# Independent Peer Review Panel

## IPRP Report No. 9, March 6, 2015

### Comments on PG&E's Central Coastal California Seismic Imaging Project Report part 3: onshore seismic studies intended to reduce the uncertainty in seismic hazard at Diablo Canyon Power Plant

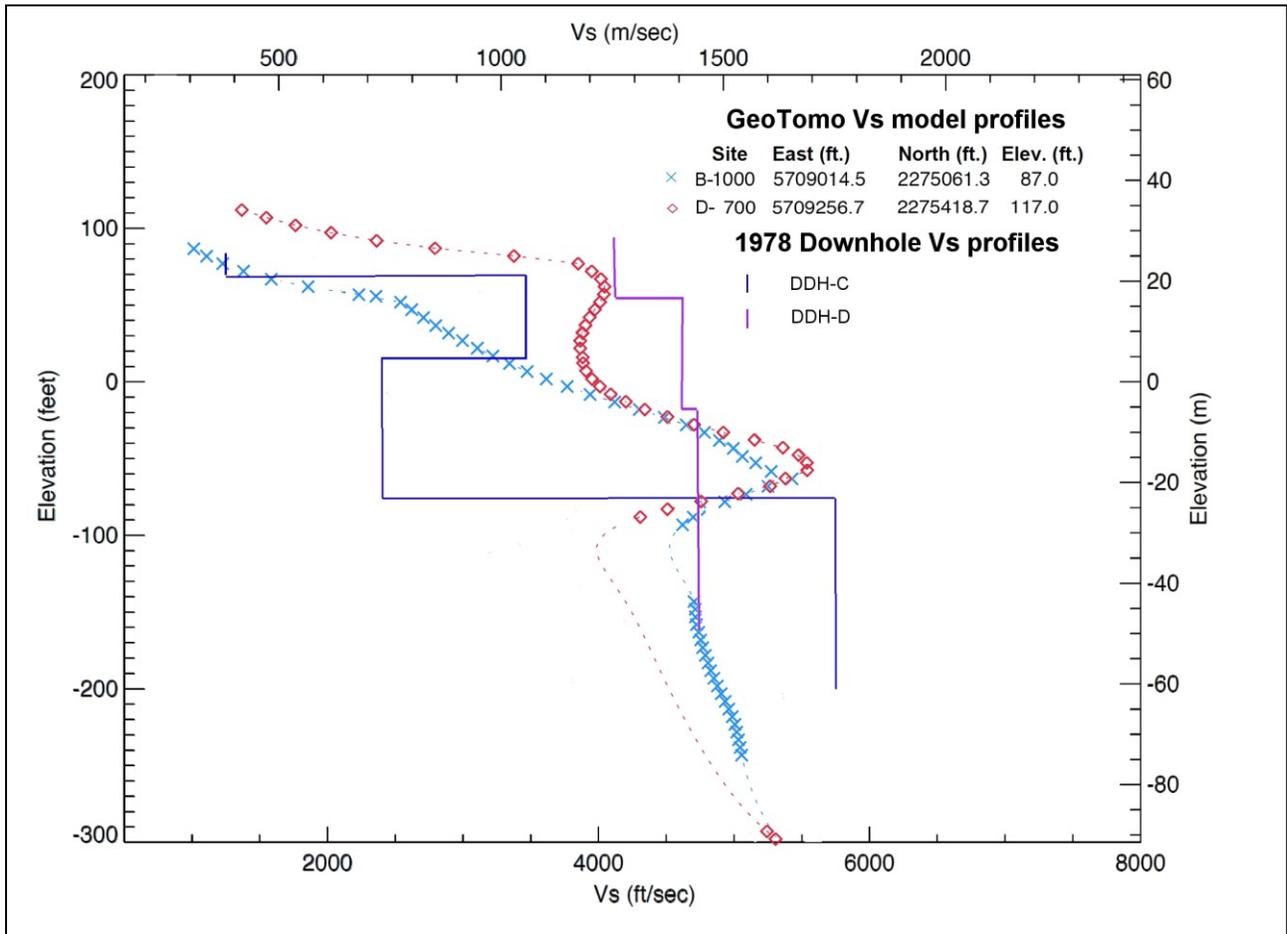
Comparison of  $V_s$  profiles from the tomographic model with profiles measured in 1978 shows broadly similar ranges of  $V_s$  and variation of  $V_s$  with depth. In detail, however,  $V_s$  profiles from the tomographic model do not appear to reproduce the variation in  $V_s$  with depth in nearby measured profiles. The most prominent feature in previous profiles is the high-velocity zone centered at approximately 50' elevation in profile DDH-C (Figure 1). The tomographic model includes a high-velocity zone near this elevation, but not in any of the profiles near the site of profile DDH-C presented on transects B-B' or D-D'. Below the high-velocity zone, profile DDH-C shows lower velocity (731 m/s) but all nearby profiles from the tomographic model show increasing velocity through this zone, reaching velocities of over 1600 m/s in the profile at 1000 ft on transect B-B' (the closest profile to DDH-C presented in the CCCSIP report). Downhole profile DDH-D shows much less variation of  $V_s$  with depth than the nearest profile shown in the CCCSIP report.

Differences between  $V_s$  profiles measured in 1978 and profiles derived from the tomographic model may reflect poor data or poor resolution in the 1978 profiles. If the 1978 downhole velocity surveys represent "ground truth", however, it appears that the tomographic model does not show some shallow high velocity layers up to 50' thick or low velocity layers up to 100' thick. The lack of correspondence between measured  $V_s$  profiles and  $V_s$  profiles estimated from the tomographic model suggests significant uncertainty remains in estimates of "site conditions" at DCP. The IPRP cannot

determine if these differences reflect poor data or analysis in one or both measurements of  $V_s$  or if both surveys are essentially correct, but have differing levels of spatial resolution. Certainly, the differences between  $V_s$  profiles from the tomographic model and previously measured  $V_s$  profiles should have been addressed in the CCCSIP report.

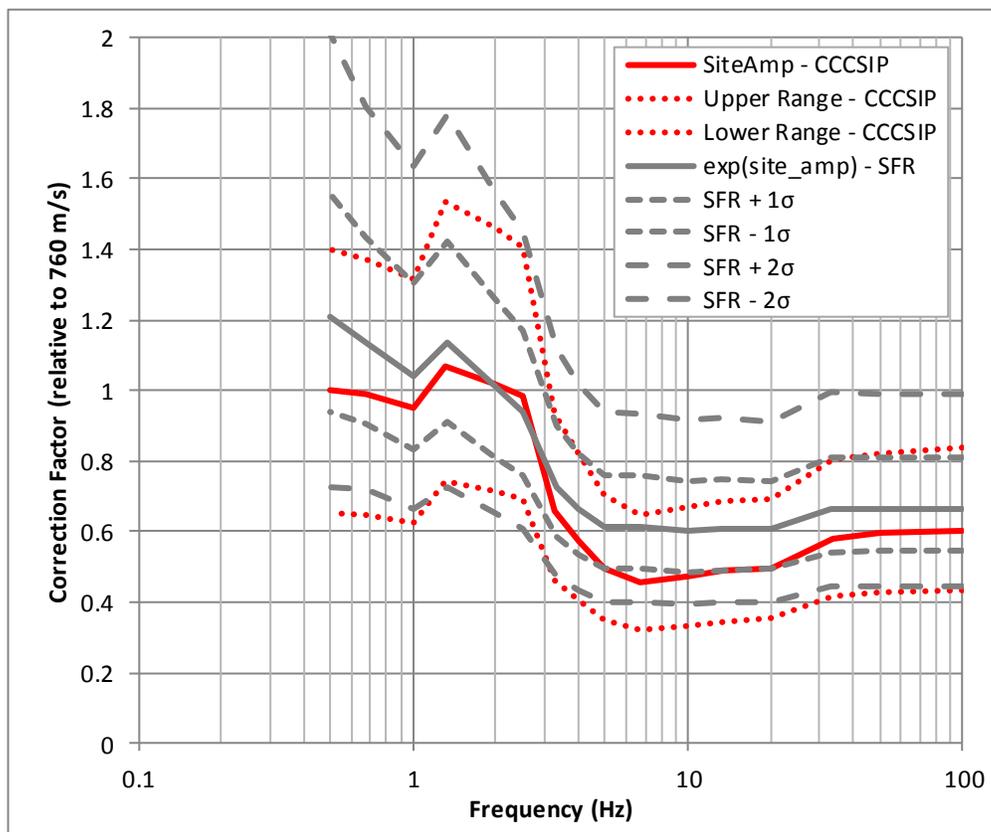
amplification factors for the foundation levels at the power block and the turbine building are listed in Table 3-3, Chapter 11 of the CCCSIP report. Figure 2 compares updated site amplification factors and associated uncertainties in the CCCSIP report with those used in the Shoreline Fault Report. In general, the new factors are slightly lower. However, given large uncertainty in site amplification, the difference should be considered insignificant.

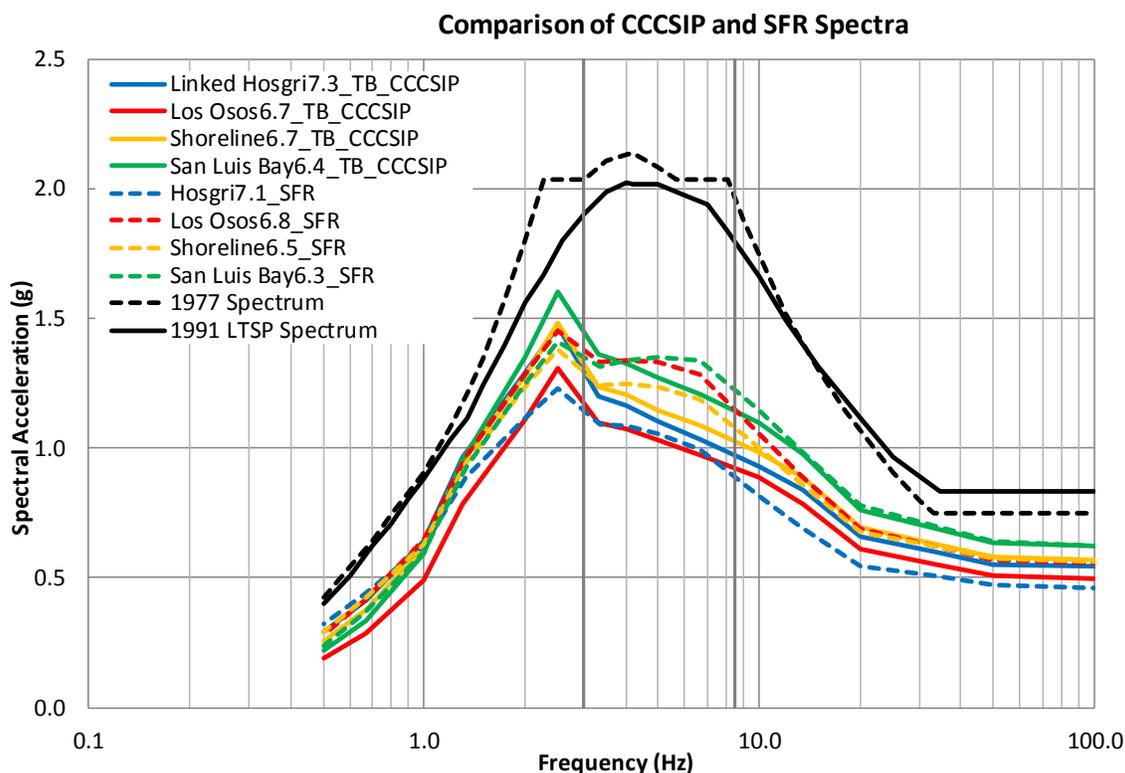
Figure 3 compares deterministic ground motion spectra presented in the CCCSIP report (for the turbine building foundation level,  $V_{S30} = 980$  m/s, solid curves) and the Shoreline Fault Report (for the DCPD site with  $V_{S30} = 1200$  m/s, dashed curves) for the four most important fault sources affecting the DCPD site. The PG&E 1991 LTSP/SSER 34, the 1977 HE (Hosgri Earthquake) design spectrum, and the frequency range important to DCPD structures (marked by vertical dark grey lines) are plotted for reference. Although the CCCSIP updates resulted in different ground motions for individual scenarios, there is little difference in estimated ground motion portrayed by the four scenarios as a group. Ground motion is higher for the linked Hosgri and San Simeon M7.3 scenario compared to the SFR Hosgri M7.1 scenario, except at frequency lower than 1 Hz. The updated Los Osos M6.7 scenario resulted in lower ground motions across the spectrum due to combined effects of the new GMPEs, slightly lower site amplification factors, and steeper minimum dip angle. For the Shoreline and San Luis Bay Fault scenarios, slightly lower ground motions were predicted by the CCCSIP updates for frequency range of 3 to 10 Hz. All scenario spectra fall below the 1991 LTSP and the 1977 HE design spectra. For each earthquake scenario, the CCCSIP deterministic spectrum for the power block foundation level ( $V_{S30} = 1200$  m/s) is slightly lower than the CCCSIP spectra for the turbine building foundation level shown in Figure 3 due to higher  $V_{S30}$  value at the power block foundation level.

**Figure 4. “Tornado Plot” ranking sensitivity of ground motion hazards to uncertainty in input parameters (presented by Norm Abrahamson at the January 8, 2015 IPRP public meeting).**

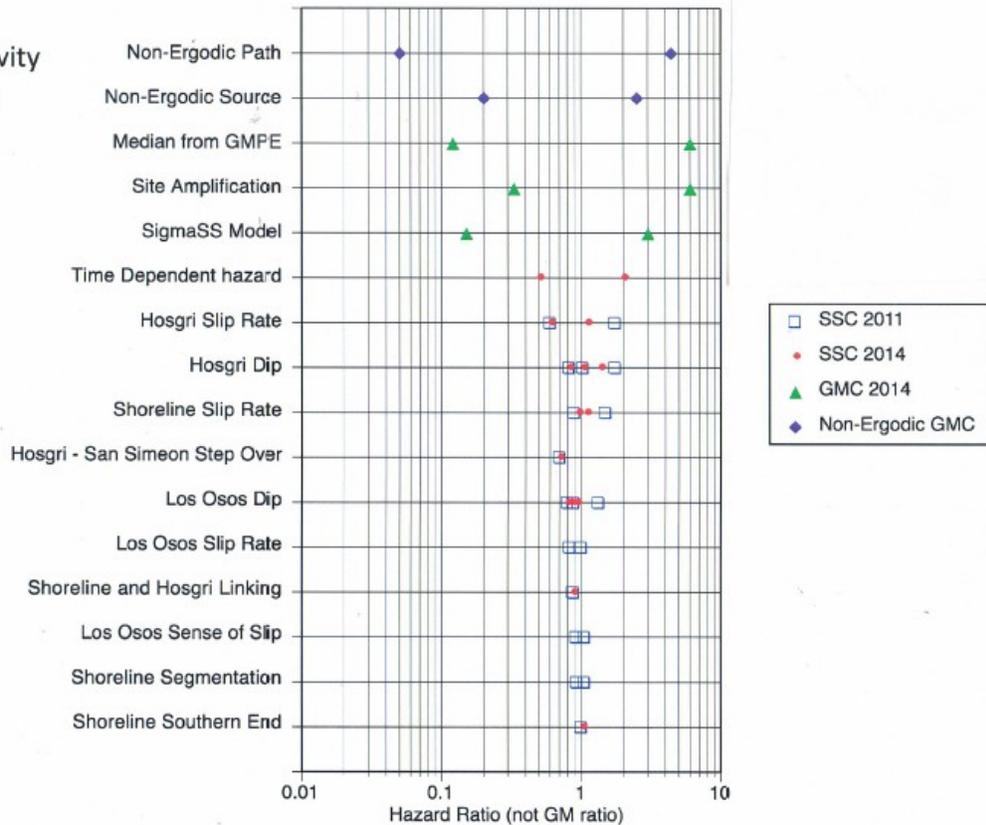
The updated tornado plot illustrates the reduction of uncertainties in some source parameters based on information developed by the AB1632 studies as reported in the CCCSIP. We note that uncertainty reductions shown in the updated tornado plot is based on PG&E's updated PSHA analyses as part of the SSHAC process. IPRP has not reviewed these new calculations and cannot comment on whether the reductions seen on the updated tornado plot are reasonable.

The most striking feature of this updated tornado plot is the 6 items related to ground motion calculation on the top of the tornado that have considerably greater uncertainty and hazard sensitivity compared to the source parameters (lower part of the tornado starting from Hosgri slip rate). The IPRP previously recognized the importance of ground motion calculation parameters (including site specific amplification and ground

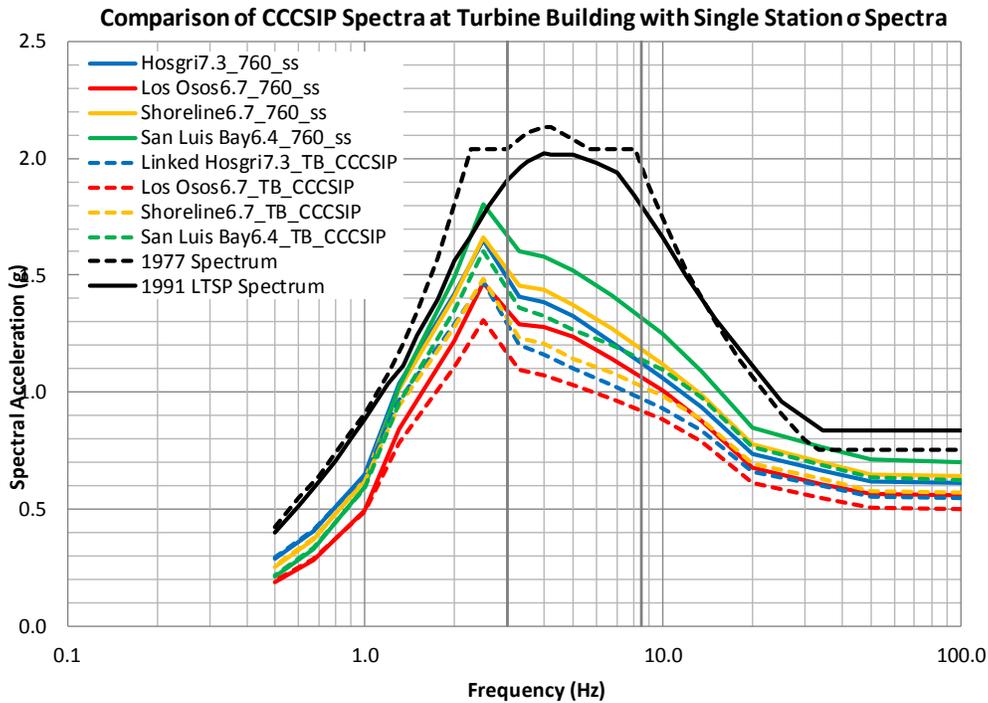
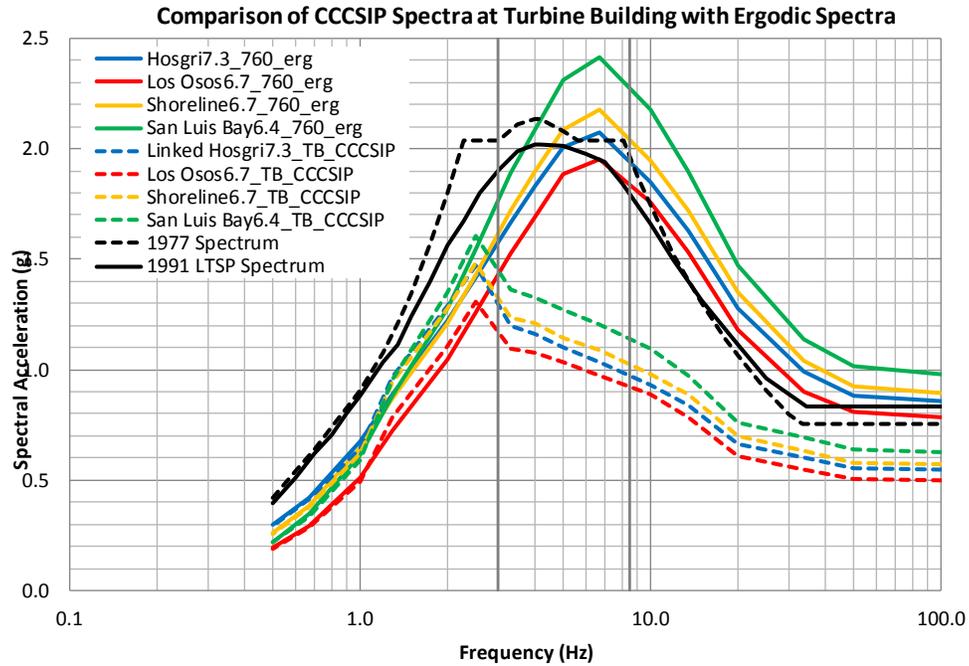
Figure 5 further illustrates the significant impact of ground motion sigma model and site amplification on estimated ground motions. The sensitivity cases illustrated in Figure 5 are based on earthquake scenarios and site amplification parameters developed in the CCCSIP report and the NGA West2 GMPEs. The two components of the overall site amplification (i.e., site-specific term and  $V_{S30}$  scaling) are separated to illustrate their relative importance.

Figure 5 compares the CCCSIP deterministic spectra for the turbine building foundation (calculated using the single station sigma assumption, site-specific term, its uncertainty, and scaling from  $V_{S30}$  of 760 m/s to 980 m/s) with two sensitivity cases: (a) an average site with  $V_{S30}$  of 760 m/s using the ergodic assumption (i.e., 84<sup>th</sup> percentile ground motion calculated directly using GMPEs); and (b) a DCPD site with  $V_{S30}$  of 760 m/s using the single station sigma assumption, the site-specific term and its uncertainty (i.e.,

Figure 5a shows that the deterministic spectra calculated based on the ergodic assumption exceed the 1977 HE and the 1991 LTSP spectra for all but one scenarios in the period range important to DCPD, which re-illustrates observations made in the IPRP Report No. 6 and depicted in Figure 7c of that report. Scaling of  $V_{S30}$  from 760 m/s to 980 m/s decreases deterministic ground motion across the spectrum, except for frequencies less than 1 Hz (Figure 5b). Differences between the  $V_{S30}$  of 760 m/s cases (solid curves) shown in Figures 5a and 5b reflect differences when ergodic assumption is used (Figure 5a) versus when single station sigma with site specific term is used (Figure 5b). For the DCPD site, the use of single station sigma with site-specific term appears to be the key factor that brings the deterministic spectra below the original design spectra.

While the single station sigma assumption and especially the site term have a significant effect on hazard, the site term is based on the observations of only two earthquakes. As described in IPRP Report No. 6, the IPRP is not convinced that the “site term” reflects some property of the site that would affect all earthquakes recorded at DCPD. The alternative hypothesis that additional factors related to the particular source or paths of those two earthquakes remains at least as plausible. The CCCSIP report does not include any additional studies to address this issue. The 3D site response analyses proposed by PG&E will not address whether single station sigma model is more reasonable than the ergodic assumption, nor will it reduce uncertainty in the site specific term that is calculated based on two recorded earthquakes. The proposed 3D site response model will address  $V_{S30}$  scaling and the effect of large variability in  $V_{S30}$  values at the DCPD site.

**Figure 6. Comparison of deterministic ground motion spectra for the Shoreline Fault rupture linked with the Hosgri and San Simeon Faults.**

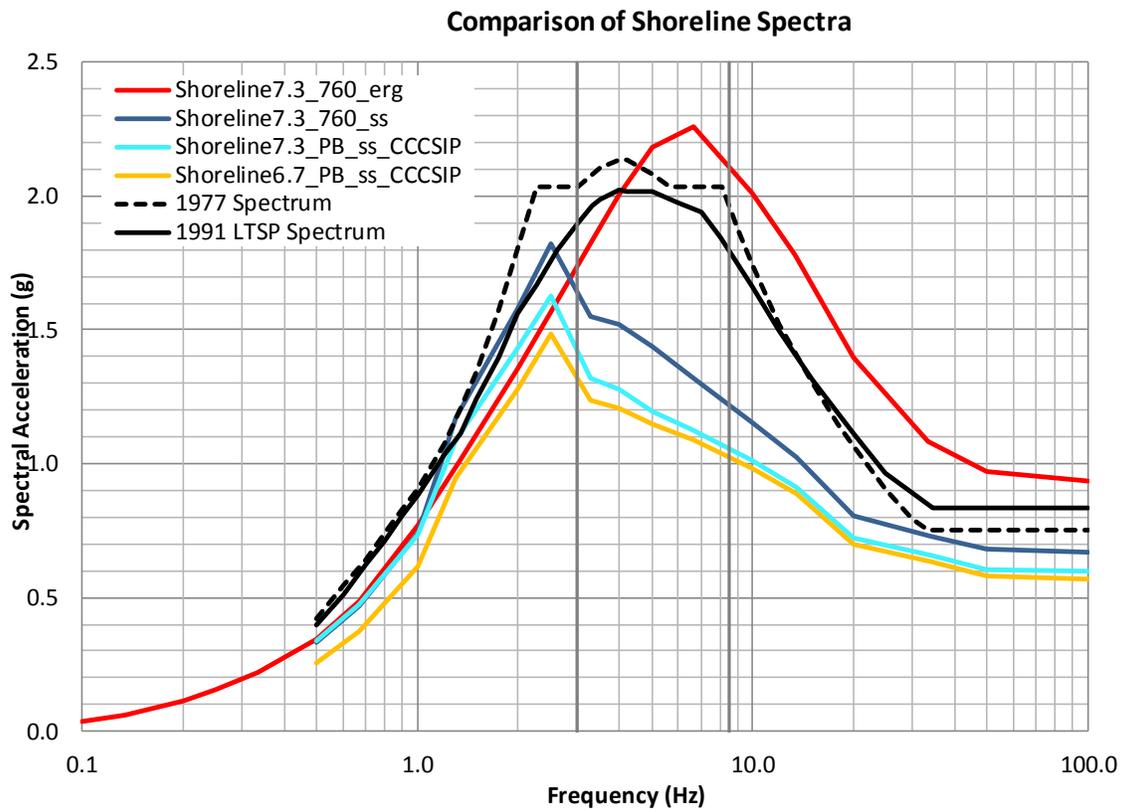
Figure 6 compares deterministic spectra for the CCCSIP sensitivity scenario assuming linked co-seismic rupture of the Shoreline, Hosgri, and San Simeon Faults (M7.3). It shows that deterministic ground motion increases across the spectrum as magnitude for the Shoreline Fault rupture increases from 6.7 to 7.3. This figure also shows increased ground motion as  $V_{S30}$  decreases from 1200 m/s [at the power block foundation level] to 760 m/s. More significantly, the figure shows, once again, that the most influential factor affecting deterministic ground motion estimates is the single station sigma assumption and the site term.
